NUMBER: 19-006-05

GROUP: Steering

THIS BULLETIN SUPERSEDES SERVICE BULLETIN 19-004-03, DATED AUGUST 29, 2003, WHICH SHOULD BE REMOVED FROM YOUR FILES. THIS IS A COMPLETE REVISION AND NO ASTERISKS HAVE BEEN USED TO HIGHLIGHT REVISIONS.

Steering Shudder

Fig. 1 POWER STEERING COOLER LOOP

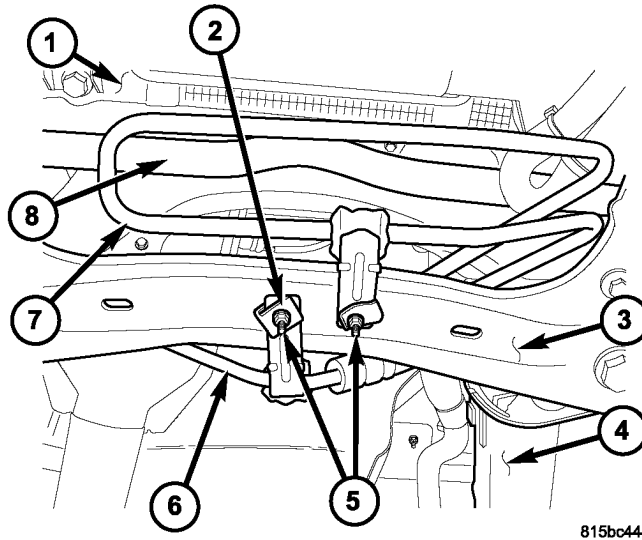
7. Raise the vehicle on an appropriate hoist.
8. Remove the fuel vapor canister.
9. Locate the bracket connecting the power steering return line cooler loop to the cradle reinforcement plate (Fig. 1).

-
10. Remove the fasteners connecting the cooler line to the reinforcement plate. Save the fasteners for use in [Step #17](#).
 11. Locate the bracket connecting the power steering pressure line to the cradle reinforcement plate ([Fig. 1](#)).
 12. Remove the fastener connecting the bracket to the reinforcement plate. Save the fastener for use in [Step #18](#).
 13. Remove and discard the J/U nut clip on the bracket.
 14. Locate and unscrew the tube nut connecting the power steering return line to the steering gear pinion housing.

Fig. 3 HOSE ROUTING - STANDARD COOLER ON LEFT, H/D COOLER ON RIGHT

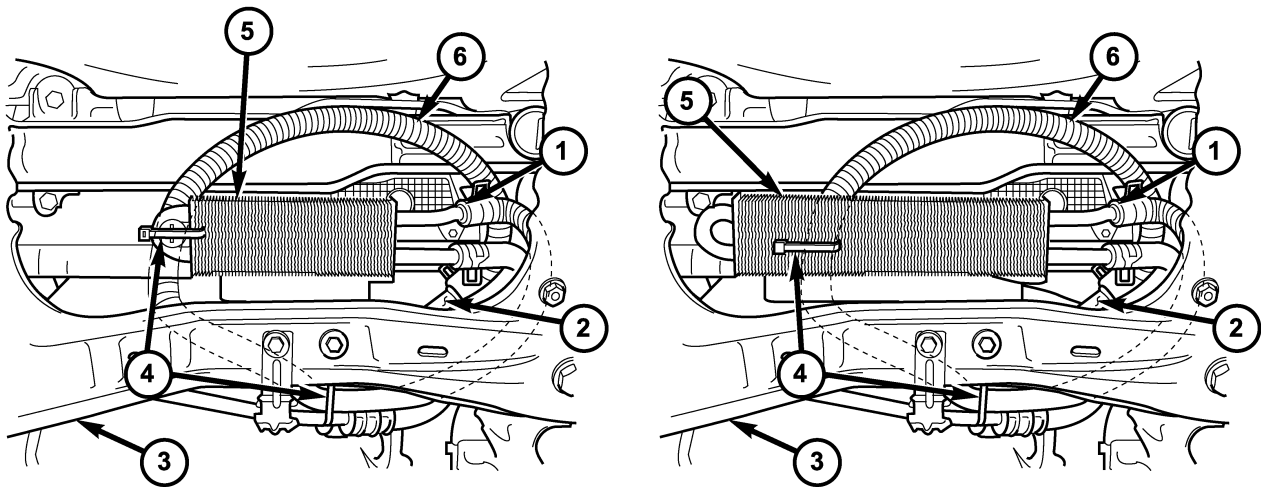
8. Wrap the hose clockwise around the perimeter and on top of the power steering cooler as shown in (Fig. 3). Install the hose and tension clamp to the power steering return tube.

-
9. Use two tie straps to strap the return hose to the power steering cooler and pressure steering hose shown in (Fig. 3).
 10. Lower vehicle and open hood.
 11. Proceed to "Steering/Pump - Standard Procedure".
